# Access Compliance Report

## Public Rights-of-Way

Intersection ID: 25500	Main Street: PINEVILLE-MATTHEWS_RD	Cross Street: STRAWBERRY_LN	Location: SE
ADA ID: 90294FD7CEB1	Ramp Type: PerpDiag	Initial Pass/Fail: Fail	Overall Compliance: No
			Severity Score: 21.25

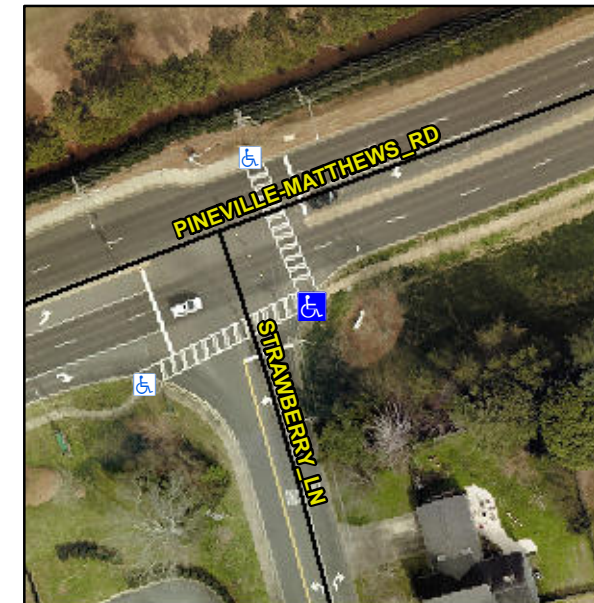
**Not Found, R304.5.1, R304.2.2**

Compliance	Description	Data	Compliance	Description	Data
N/A	Ramp Length (in)	60.0	No	Ramp Slope (%)	10.6
No	Ramp Width (in)	45.0	Yes	Ramp XSlope (%)	2.0
N/A	Flare Type LT	N/A	N/A	Flare Type RT	N/A
N/A	Flare Slope LT (%)	N/A	N/A	Flare Slope RT (%)	N/A
N/A	Flare Traversable LT?	N/A	N/A	Flare Traversable RT?	N/A
N/A	Landing Length (in)	N/A	N/A	DWS Provided?	N/A
N/A	Landing Width (in)	N/A	N/A	DWS Contrast?	N/A
N/A	Landing Slope (%)	N/A	N/A	DWS Length (in)	N/A
N/A	Landing X Slope (%)	N/A	N/A	DWS Full Width?	N/A
N/A	Landing Curb? (Y/N)	N/A	N/A	DWS Offset (in)	N/A
N/A	Shared Landing?	N/A			
N/A	Gutter Ponding?	N/A	N/A	Gutter Slope (%)	N/A
N/A	Gutter Lip Ht (in)	N/A	N/A	Gutter X Slope (%)	N/A
N/A	Painted X Walk1?	No	N/A	Painted X Walk2?	Yes
	X Walk 1 Direction	To NW		X Walk 2 Direction	To SW
N/A	X Walk 1 Width (in)	N/A	N/A	X Walk 2 Width (in)	69.0
	X Walk 1 Slope (%)	3.8		X Walk 2 Slope (%)	1.7
	X Walk 1 X Slope (%)	0.1		X Walk 2 X Slope (%)	5.2

**Remove & Replace Curb Ramp With Two New Directional Ramps or Equivalent.**
